**PLANNED UNIT DEVELOPMENT &
SUBDIVISION STAFF REPORT****Date: March 20, 2003**

<u>DEVELOPMENT NAME</u>	West Hill LLC (Tom Carwie, Agent)
<u>SUBDIVISION NAME</u>	West Hill Subdivision
<u>LOCATION</u>	West terminus of Hilltop Drive South
<u>PRESENT ZONING</u>	R-1, Single-Family Residential
<u>AREA OF PROPERTY</u>	3.1± Acres
<u>CONTEMPLATED USE</u>	Reduced lot widths and reduced lot sizes
<u>TIME SCHEDULE FOR DEVELOPMENT</u>	Immediate
<u>ENGINEERING COMMENTS</u>	Must comply with all stormwater and flood control ordinances. Any work performed in the right of way will require a right of way permit.
<u>TRAFFIC ENGINEERING COMMENTS</u>	Driveway number, sizes, location and design to be approved by Traffic Engineering and conform to AASHTO standards.
<u>REMARKS</u>	The applicant is requesting Planned Unit Development and Subdivision approvals to construct 13 lots, with reduced widths and setbacks, along a cul de sac.

DETAIL SITE PLAN

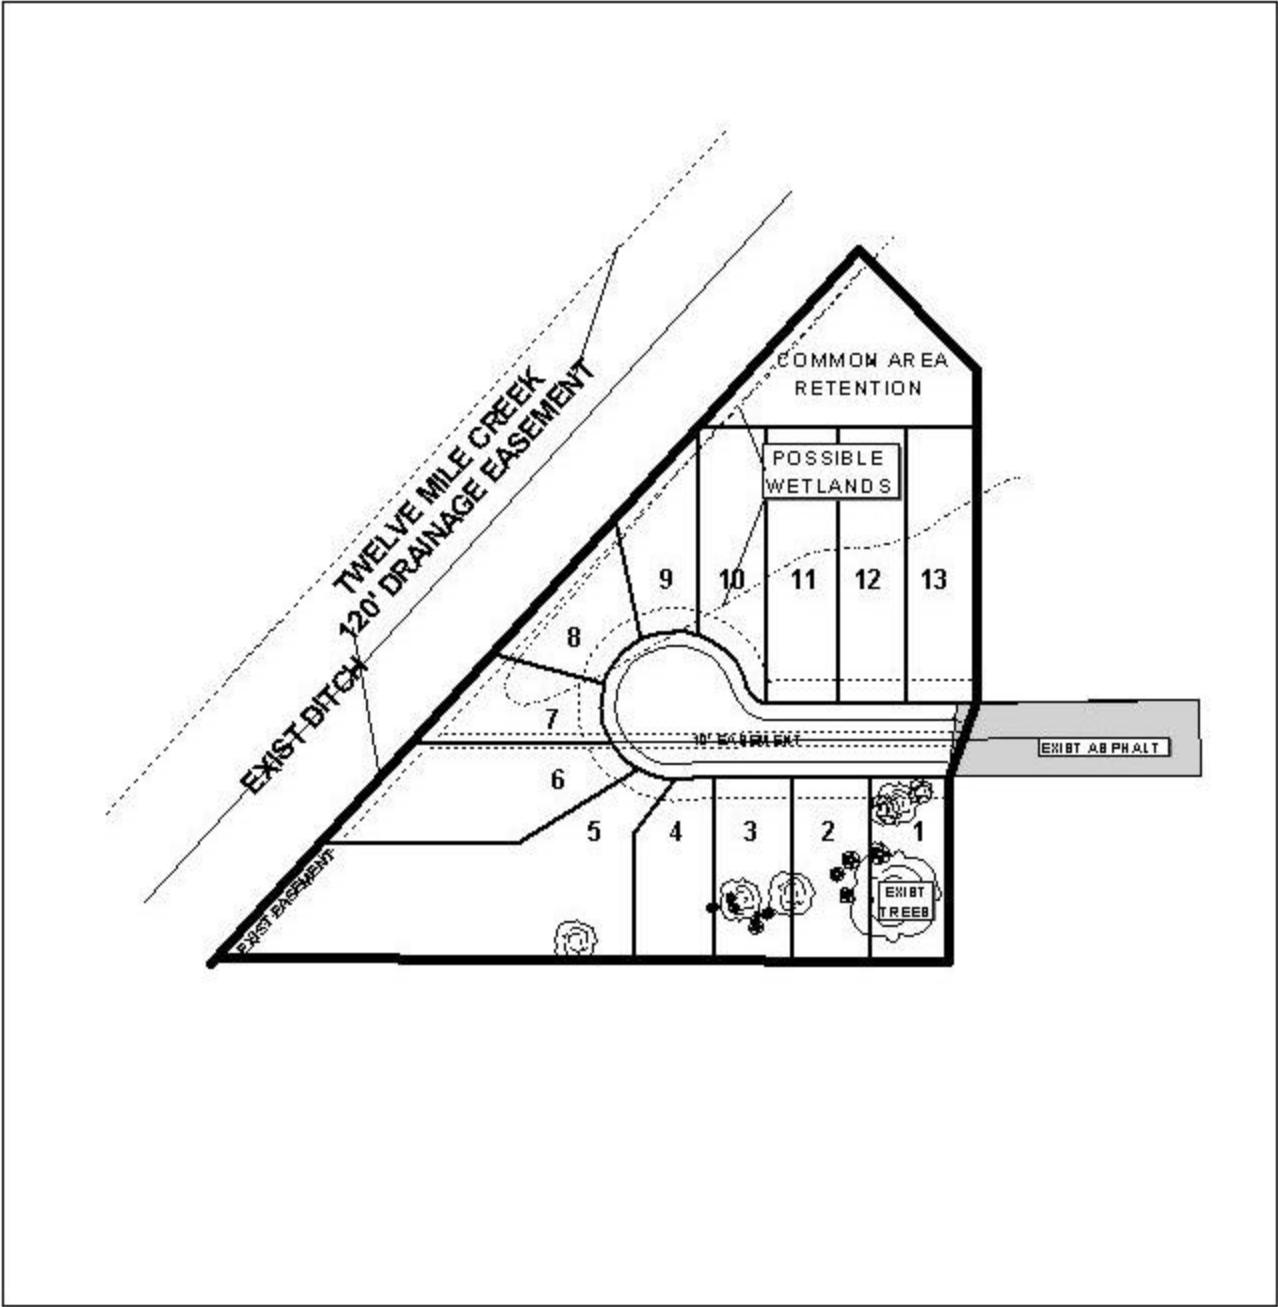
There are numerous concerns associated with the proposed development. First, there are large existing trees simply labeled oaks and magnolias (sizes are not given), which may

need preservation. Urban Forestry will provide detailed information at the public hearing. A greater concern pertains to the large area illustrated as “possible wetlands” that would render Lots 8-10 (and possibly Lot 11) not developable. Furthermore, the typical lot layout would provide a zero-setback on the East side of Lot One; standard setbacks should be provided along the boundary of the development.

Based upon the preceding, these applications are recommended for holdover to allow the applicant to address the concerns identified in this report. The additional information must be submitted by March 24th to be considered at the Commission’s April 3rd meeting.
